ADDENDUM NUMBER 3

BID/RFP TITLE: Roof Replacement at Lincoln-Hancock School

Addendum #3

SHEET TITLE:
**NEW
CONSTRUCTION
ROOF DETAILS**

8 ROOF EDGE AT POOL AND GYM
SCALE: 6"=1'-0"

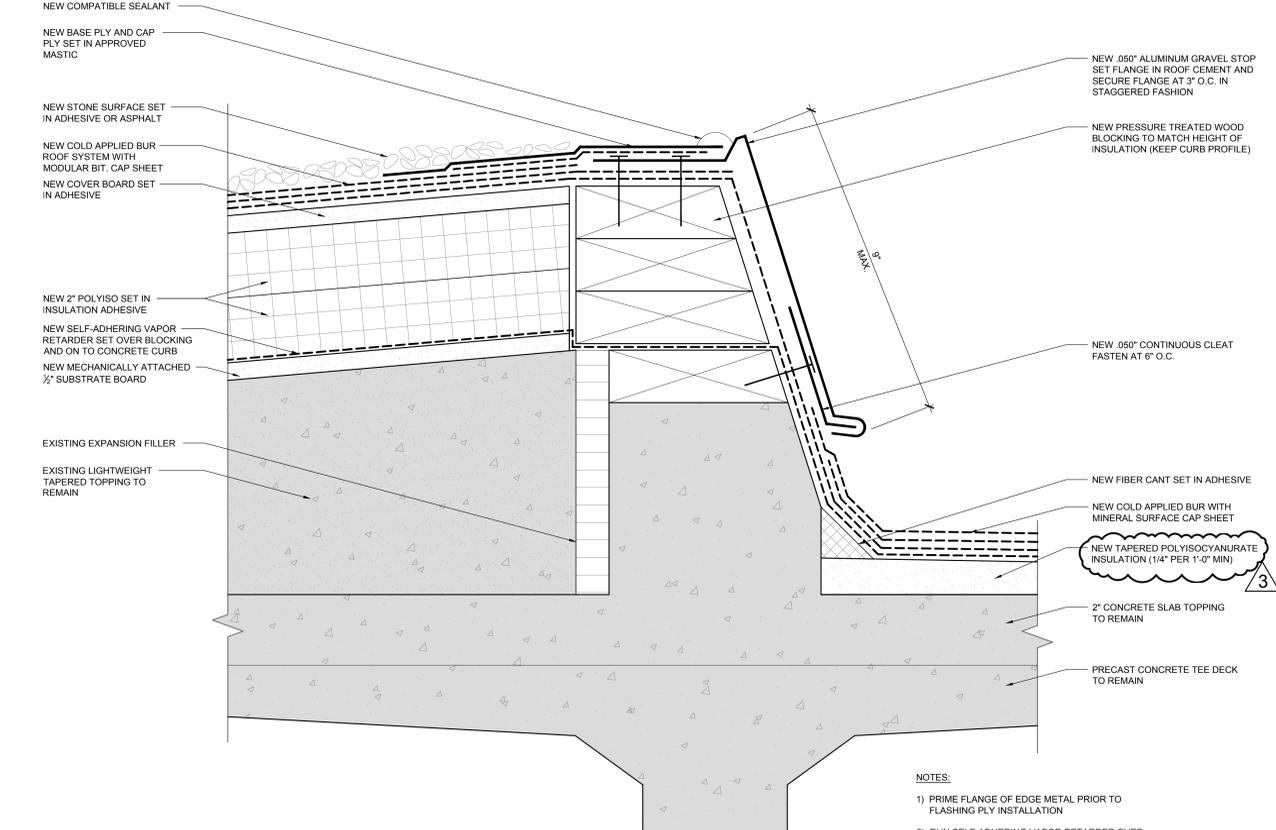
- A. Revision of the following details on Sheet A-502
1. Detail 4/A-502, Revised Detail Attached
 2. Detail 8/A-502, Revised Detail Attached

- NOTES:
- 1) PRIME FLANGE OF EDGE METAL PRIOR TO FLASHING PLY INSTALLATION
 - 2) RUN SELF-ADHERING VAPOR RETARDER OVER BLOCKING AND ON TO CONCRETE CURB.
